ASI03

Addendum

Project: Saginaw Independent Living
City of Saginaw, Texas

Addendum No. 3

C-3.0

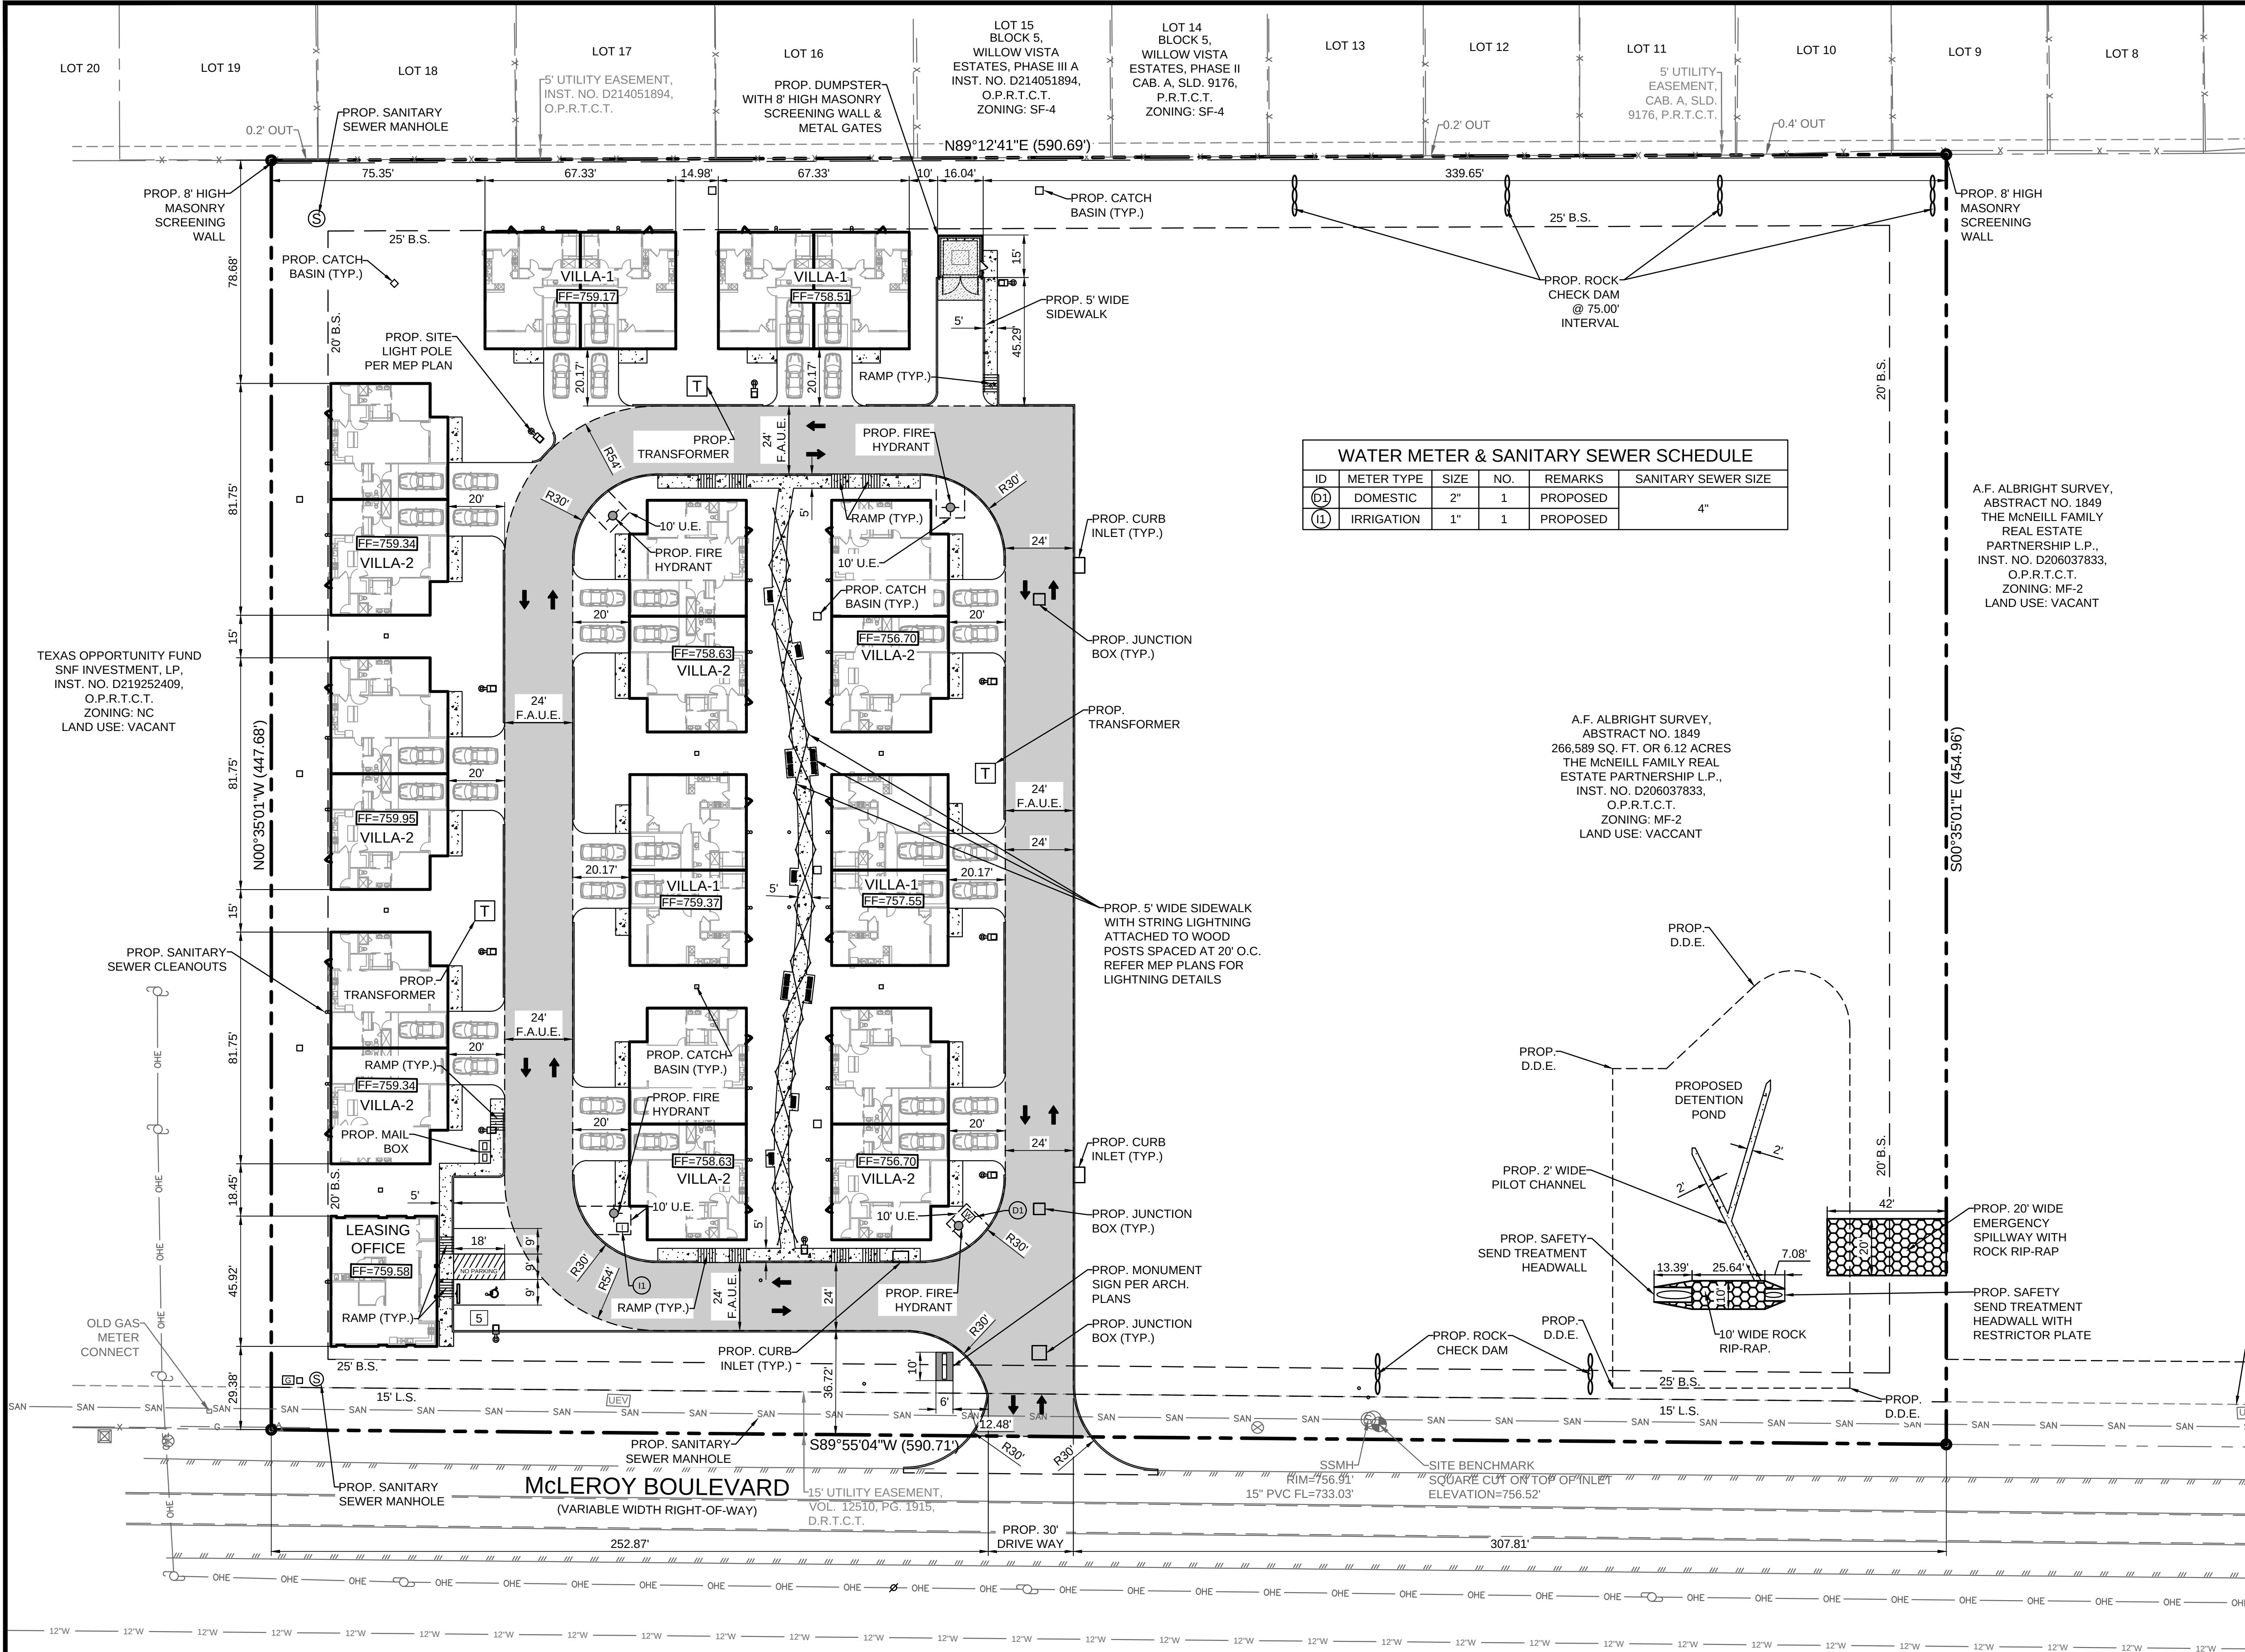
Please note that the attached drawings comply with all the items listed in item 2. Additionally, refer to sheet C-3.0 for the revised sidewalk layout.

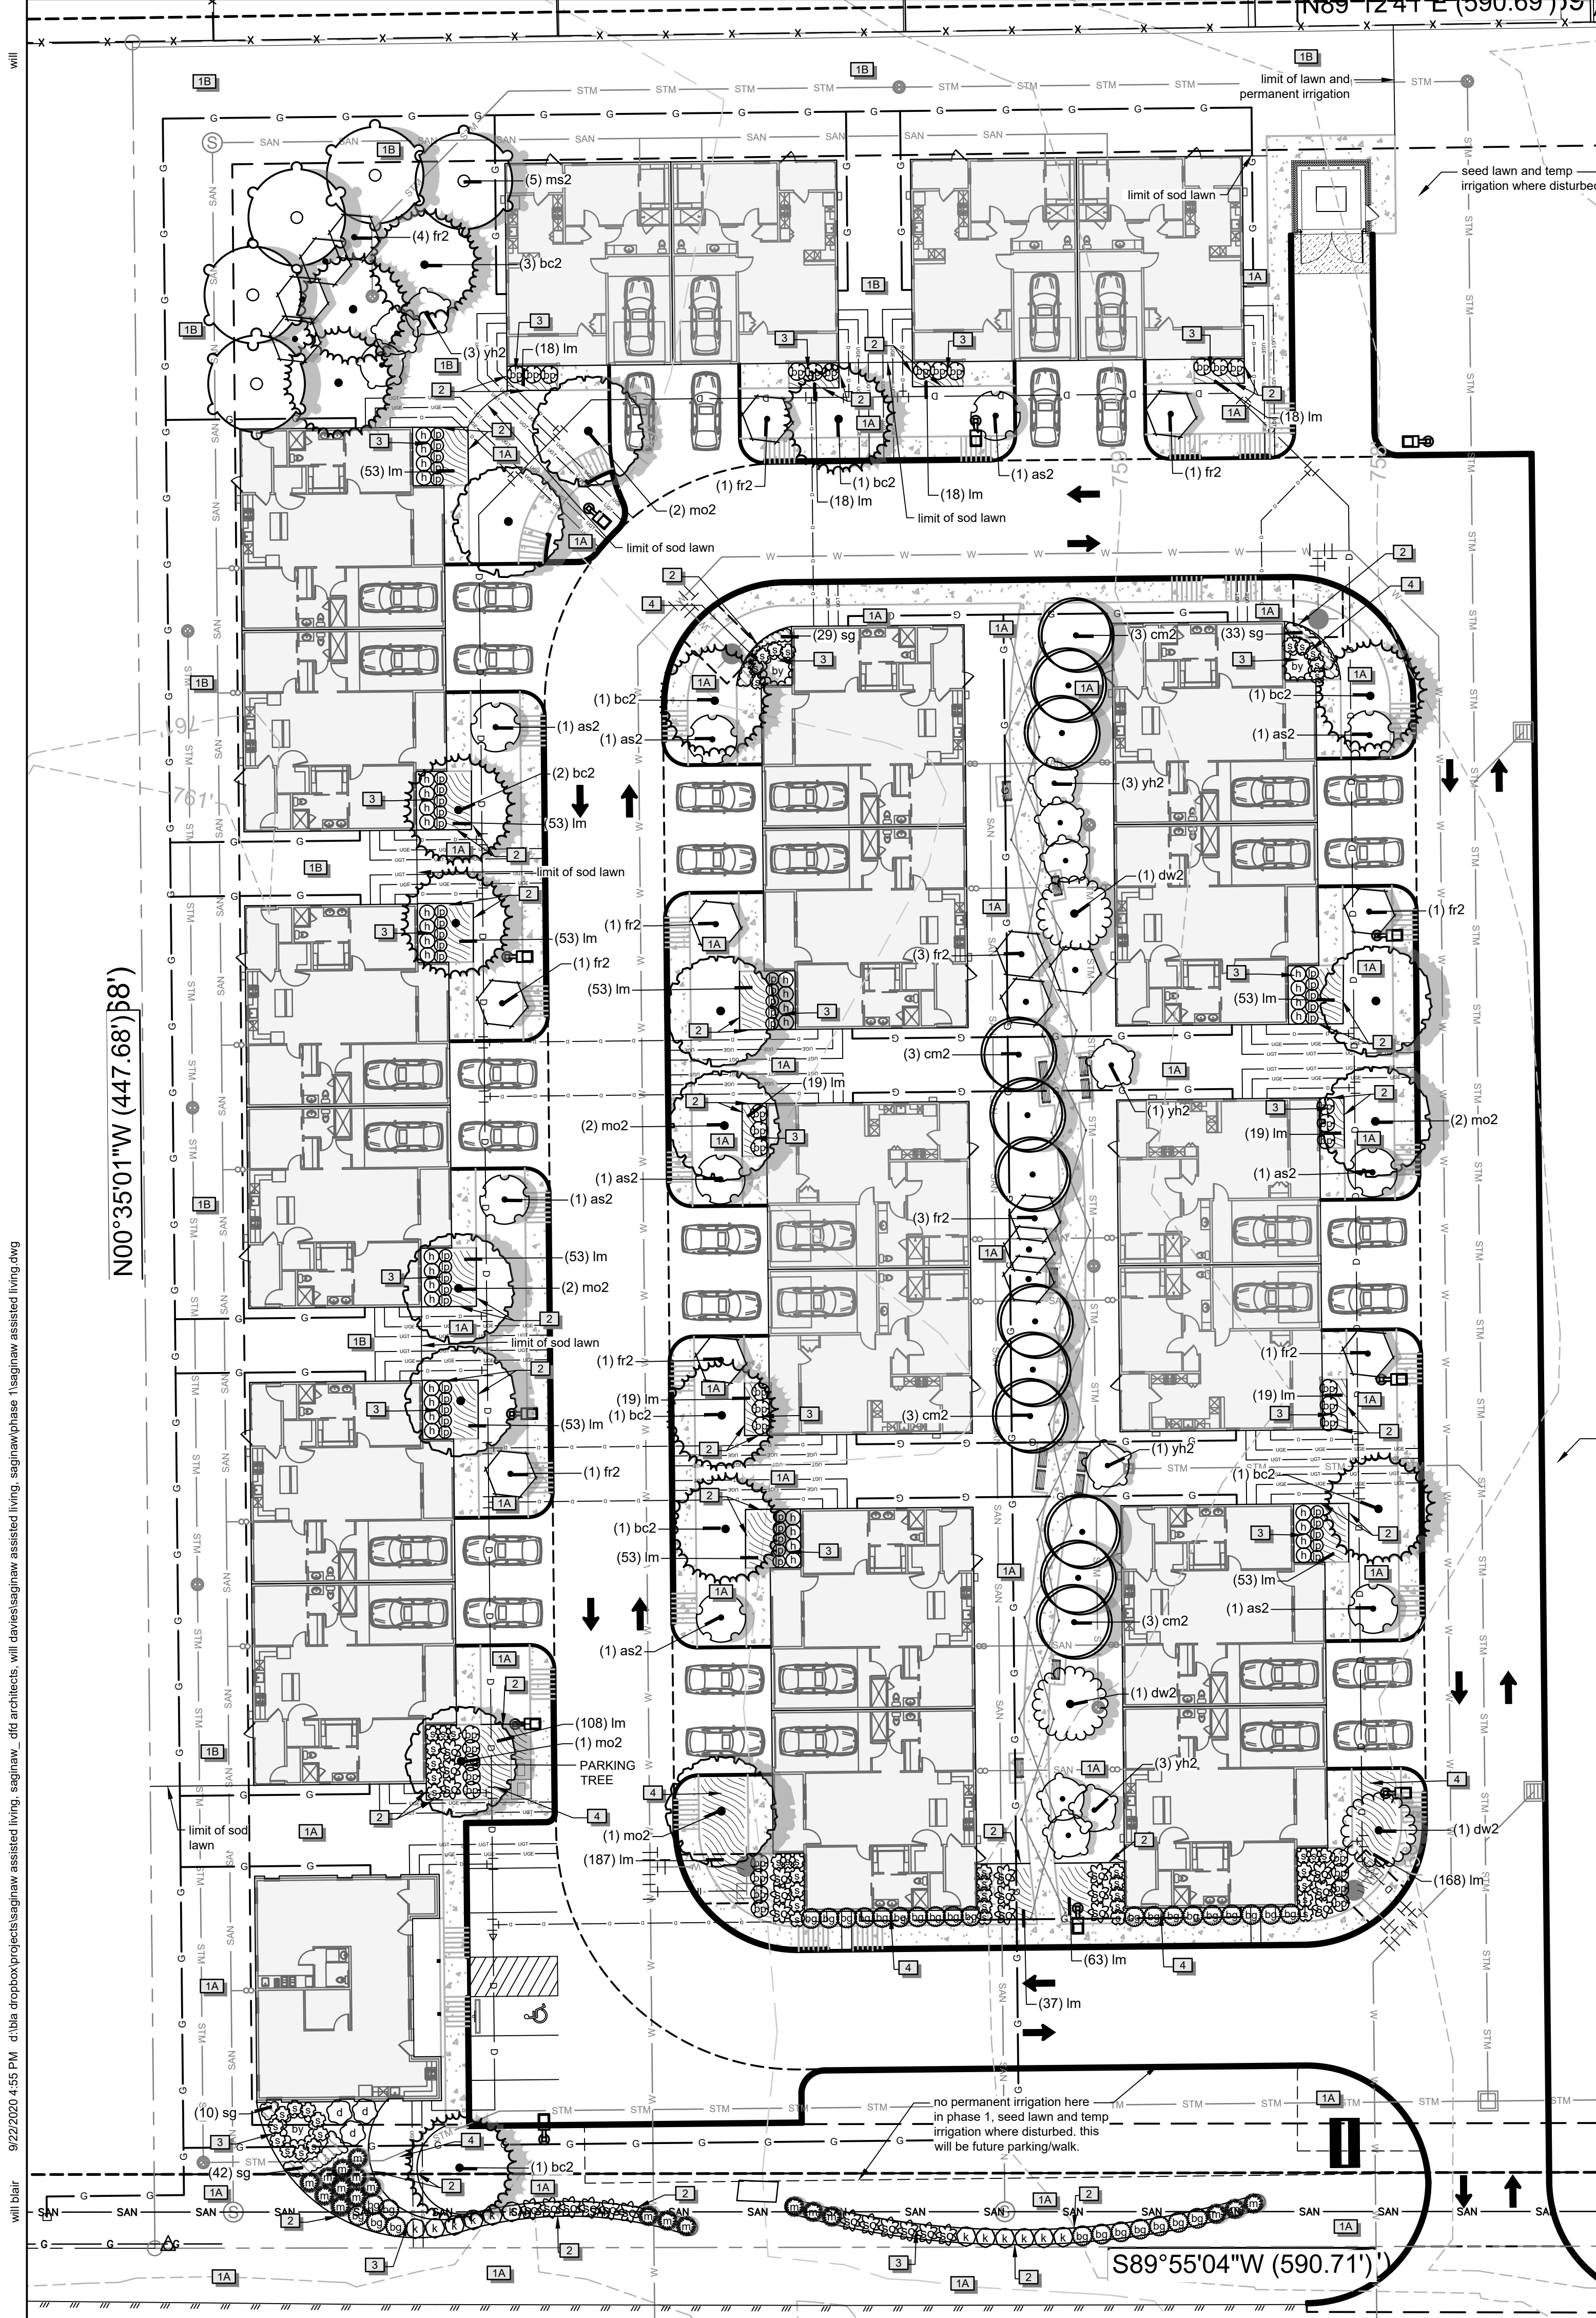
1. Enclosed please find landscape plans L1 and L2 for your reference.
2. Per Article 8. – Supplemental District Regulations EC. 8-1. – Site plan requirements Section E. Site Plan content – Item 9. - the landscape plan includes the type, location and quantity of all plant materials used for landscaping and the type, location and height of fences or screening and the plantings around them.
